February 9, 2012
U7-C-NINA-NRC-120013
10 CFR 2.390

South Texas Project
Units 3 and 4
Docket Nos. 52-012 and 52-013
Response to Requests for Additional Information

RAI 09.01.02-9**QUESTION:**

RAI 09.01.02-17**QUESTION:**

Figure 1 Comparison of Input vs. Calculated Response Spectra, Horizontal (X)

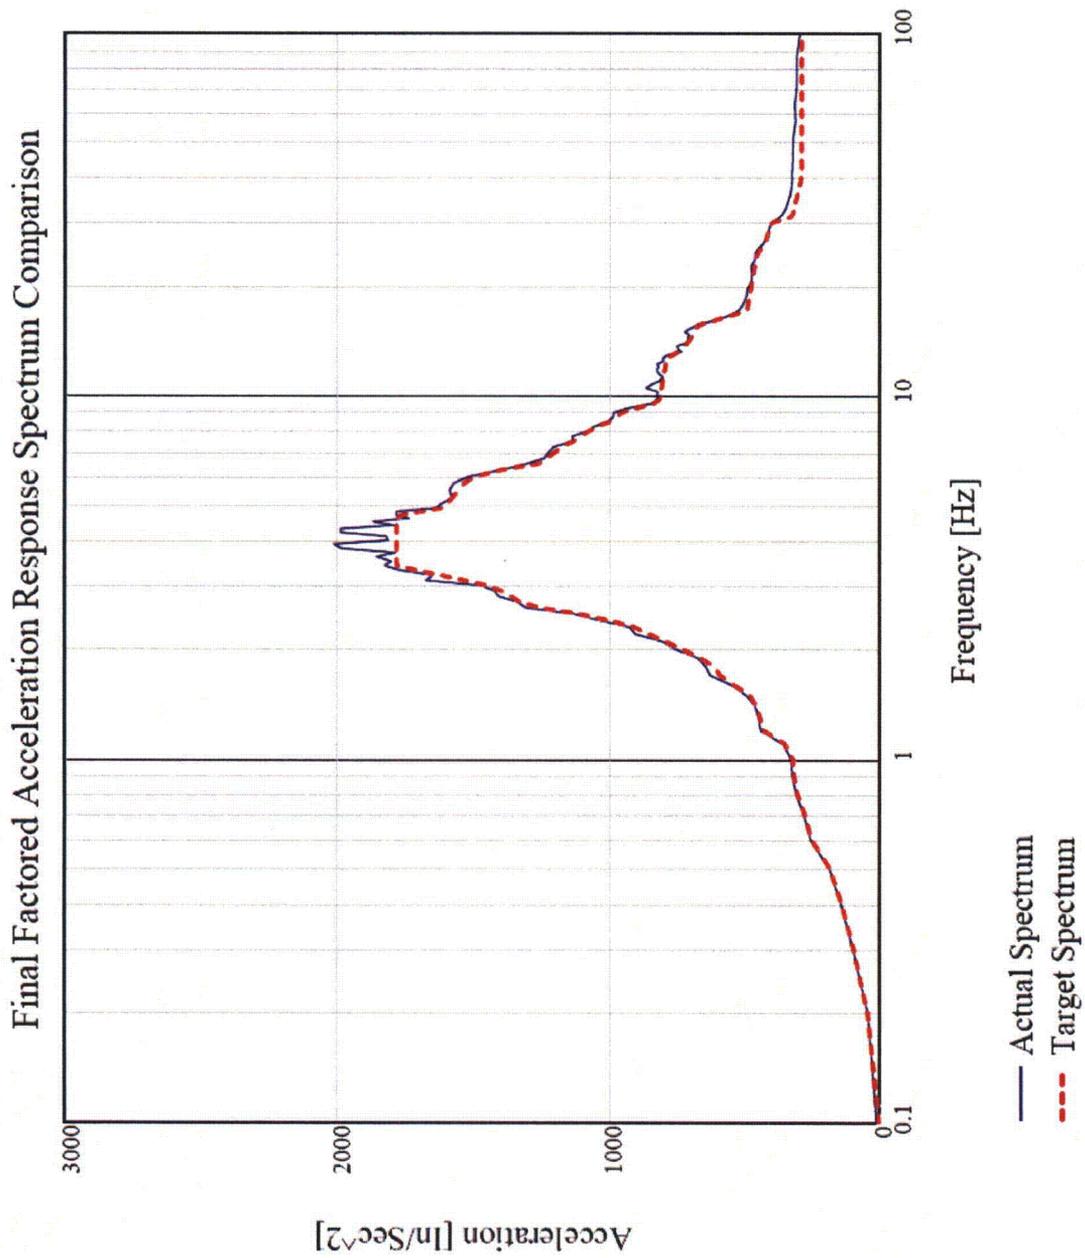
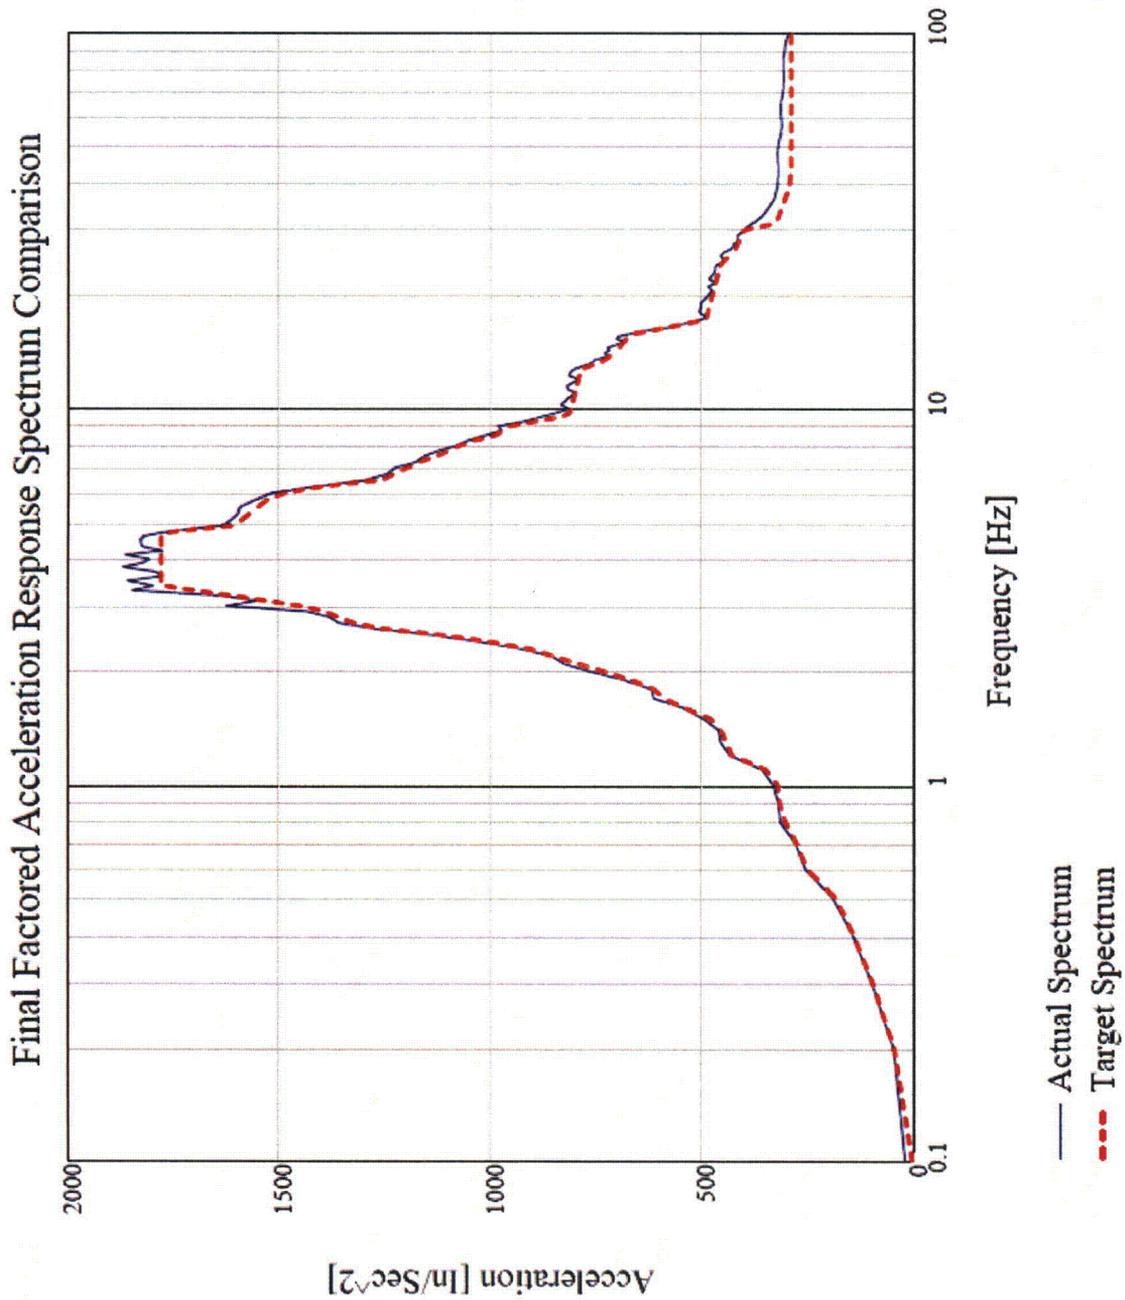
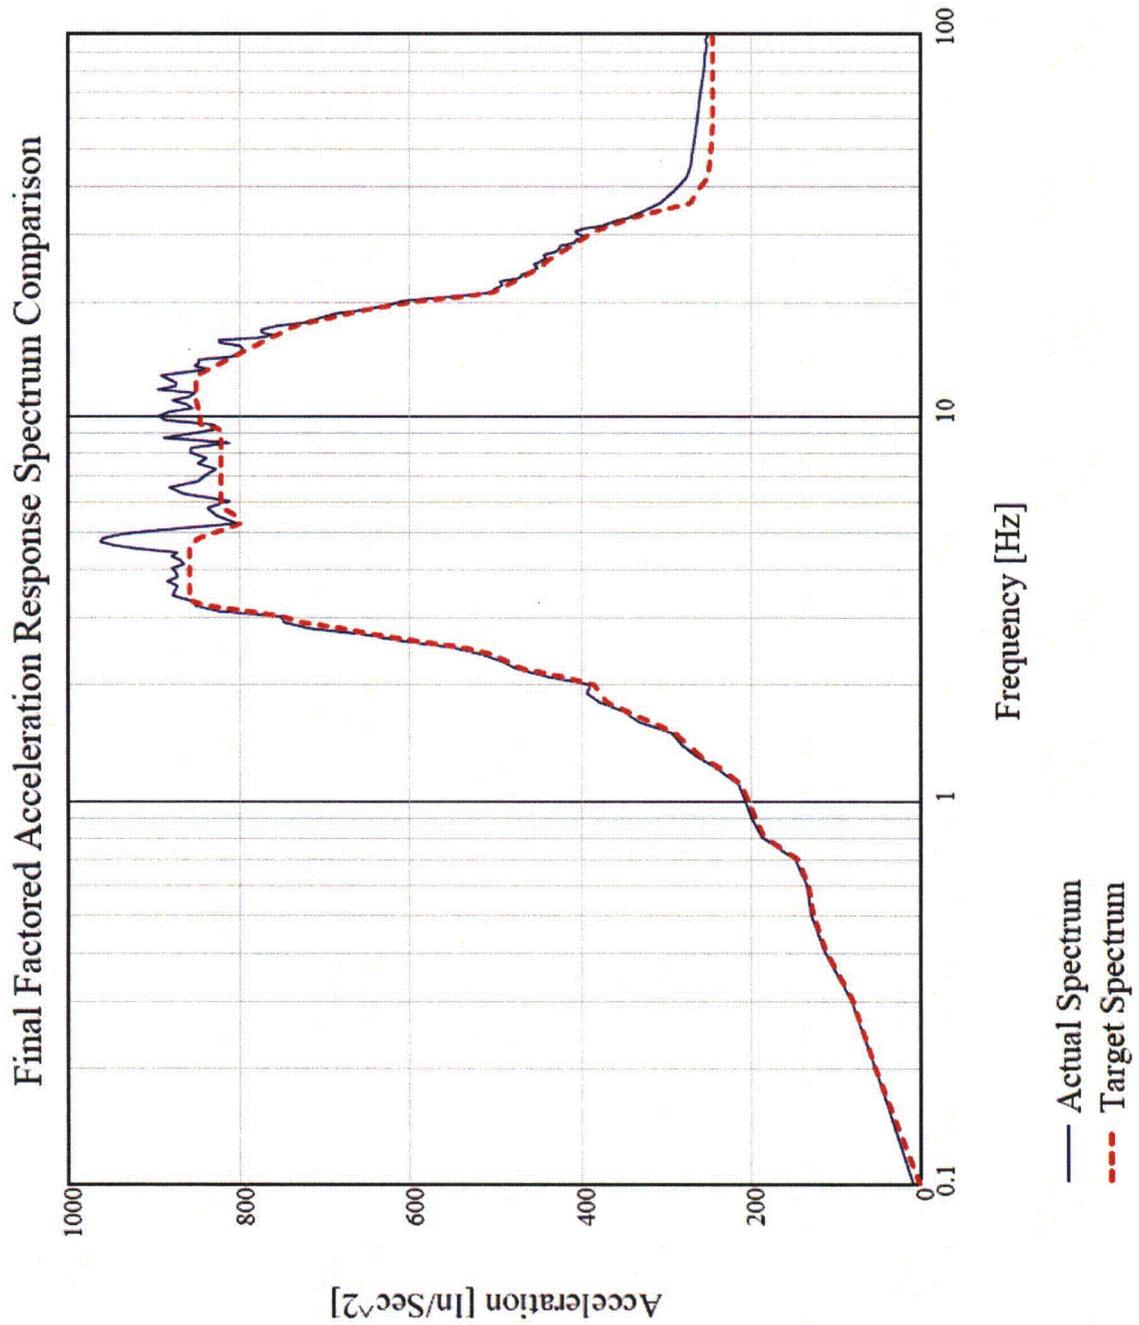
- a. Confirm that the 3 synthetic time histories have been checked against each other to ensure statistical independence. Compare the calculated correlation coefficients to the acceptance criterion of ≤ 0.16 . Include this information in the spent fuel racks technical report.
- b. Provide figures comparing the 5% damped spectra (2 horizontal, vertical) generated from the synthetic time histories to the 5% damped target spectra (horizontal, vertical) at node 100. Identify the criteria used to verify the adequacy of the match. Include this information in the spent fuel racks technical report.

- b. The following figures show the comparison of the 4% damped spectra (2 horizontal, vertical) generated from the synthetic time histories to the 4% damped target spectra (horizontal, vertical) at node 100. Per the requirements of NUREG-0800, Standard Review Plan 3.7.1, the SRP Acceptance Criteria on page 10 states that “Each calculated spectrum of the artificial time history is considered to envelop the design response spectrum when no more than five points fall below, and no more than 10 percent below, the design response spectrum.” Synthetic time histories were created for 4% damping at Node 100, per the requirements of Reg Guide 1.61, “Damping Values For Seismic Design Of Nuclear Power Plants,” as required for welded steel or bolted steel structural material with friction connections (RG 1.61, Table 1, “SSE Damping Values”), not the 5% as requested above.

The following table shows compliance to the NUREG-0800, Standard Review Plan Section 3.7.1 for Response Spectra Comparison (the number of points below the target is less than or equal to 5, and the maximum percent under the target is less than 10%):

Figures 1, 2, and 3 show that the synthetic generated time histories envelop the target response spectra using 4% damping at Node 100 for all three directions. A statement summarizing that the synthetic time histories are developed using the guidance of, and meet the validation criteria of, SRP Section 3.7.1 will be included in the next revision of the spent fuel racks Technical Report.

Figure 4 Actual Raw and Average PSD vs. Target – Horizontal (X)

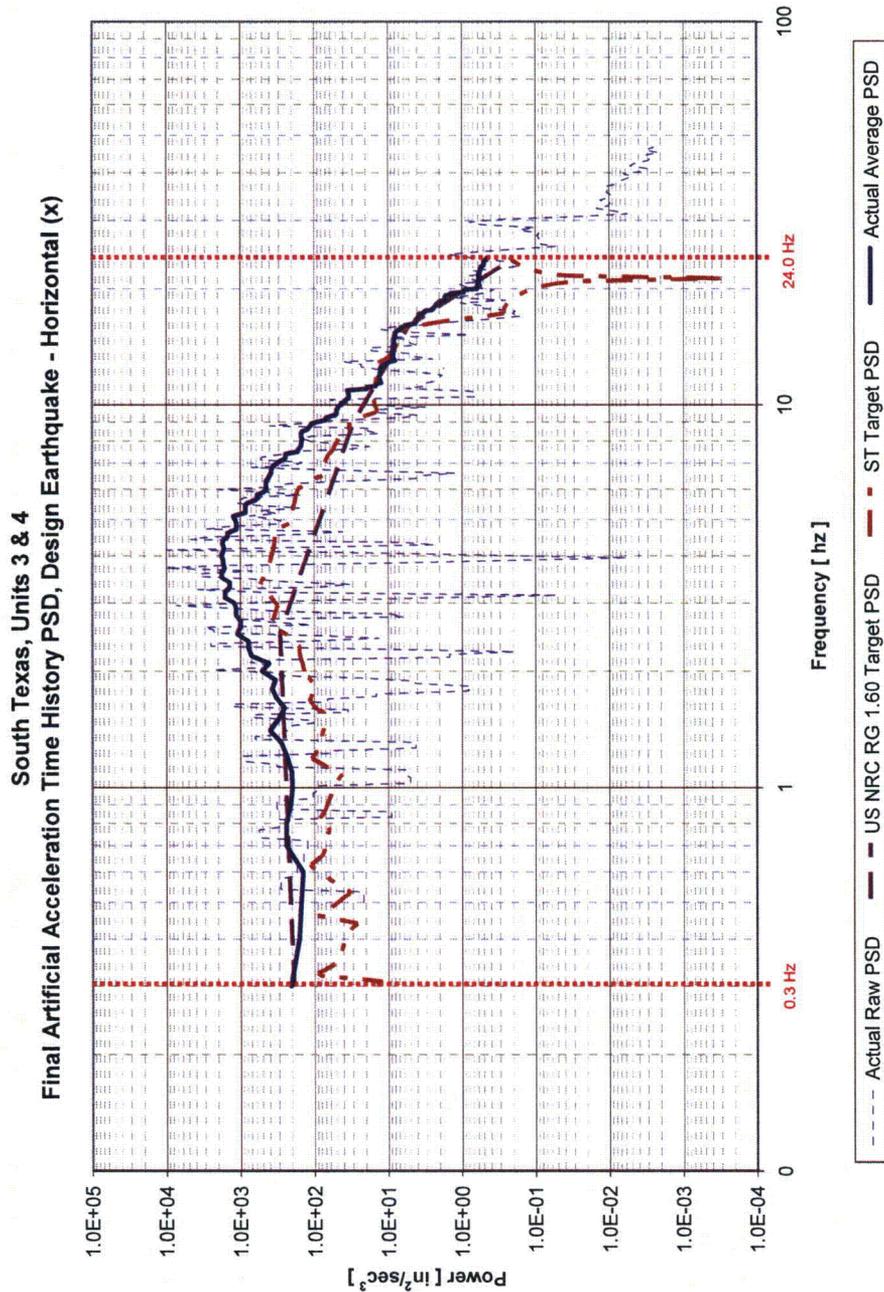
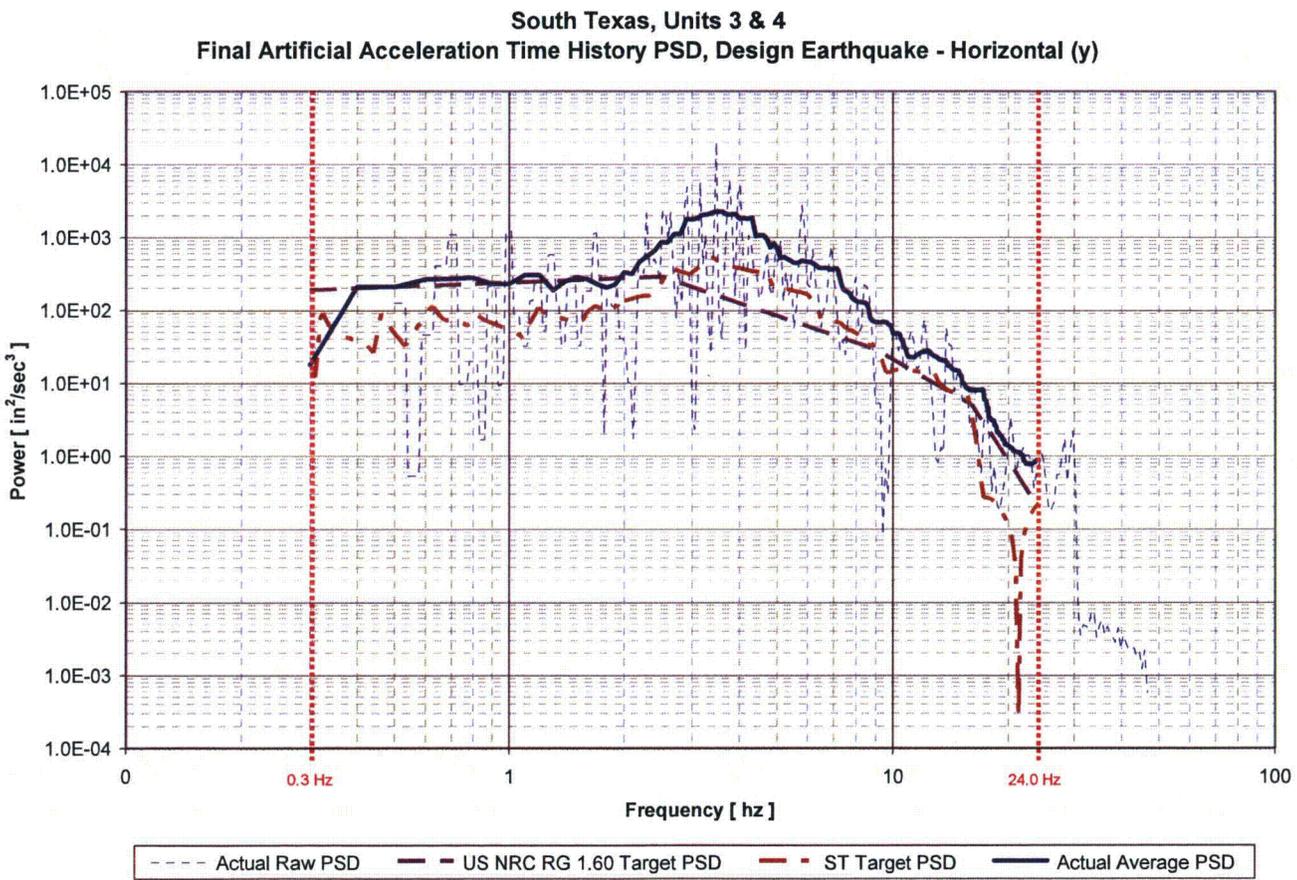
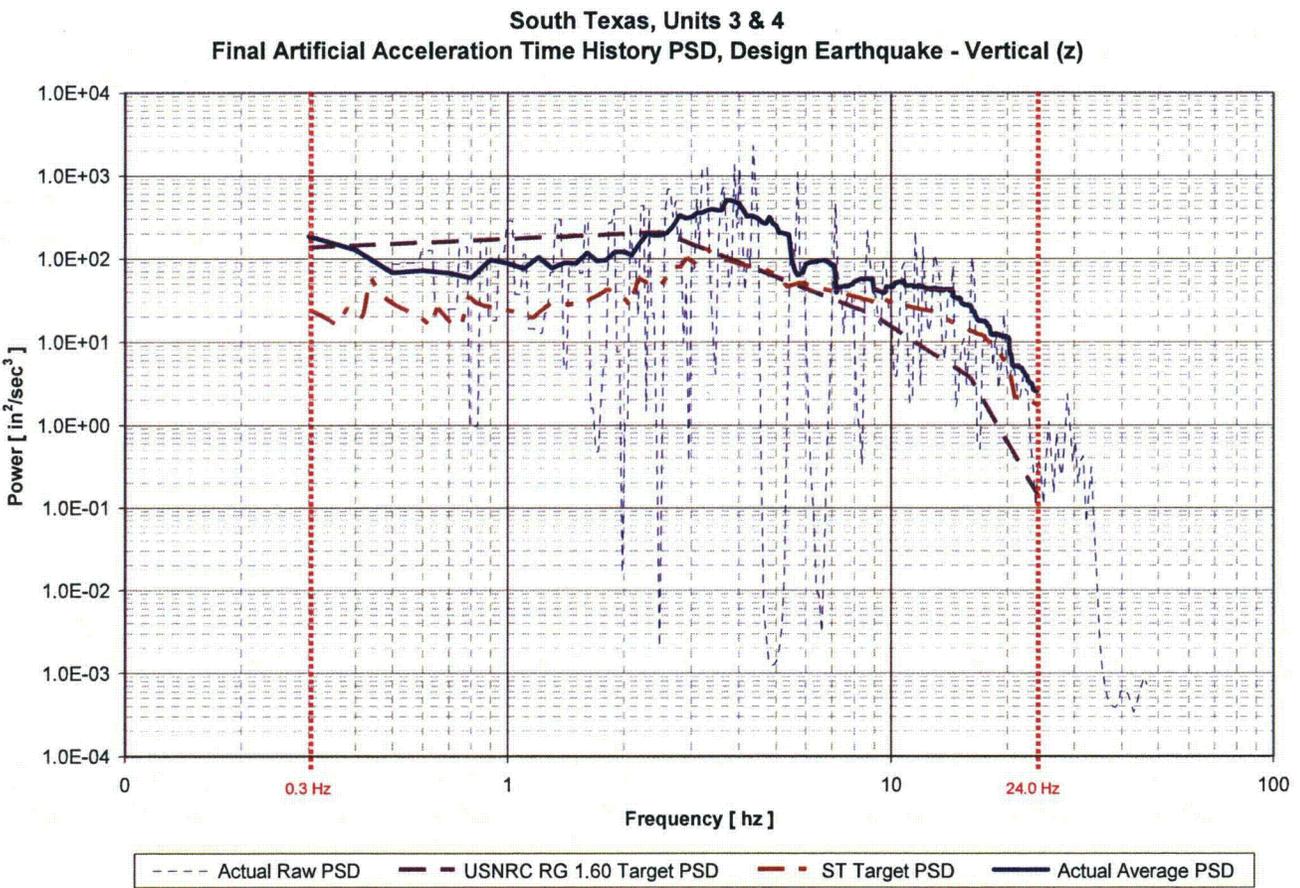
- c. Describe how target PSDs were developed for the Node 100 target spectra, and provide figures comparing the PSDs for the synthetic time histories to the PSDs for the target spectra. Identify the criteria used to verify the adequacy of the PSDs for the synthetic time histories.

Figures 4, 5, and 6 are plots of the 80% NRC target PSD function, the actual raw PSD, the actual average PSD, and the site-specific target PSD function for each case.

It can be seen that the actual average PSD curves are above the STP-specific target PSD curves with exceptions as follows:

- X direction, around 15Hz, the actual average is approximately equal to the target.
- Y direction, around 0.32 Hz, the actual average is below the target.

The PSD check that is required by SRP Section 3.7.1 is for synthetic motion generated at the ground level. Because the STP 3&4 synthetic motion is at a higher elevation within containment, the PSD check has been conservatively applied at the higher elevation. There

are two small frequency ranges (between 0.3-0.4 Hz in the horizontal “Y” direction and between 10-20 Hz in the horizontal “X” direction) where the actual PSD is below the site specific target PSD. The actual PSD is very close to the target PSD within these frequency ranges, and because the input response spectra is at an elevation above ground level, the artificial time history data is deemed acceptable.
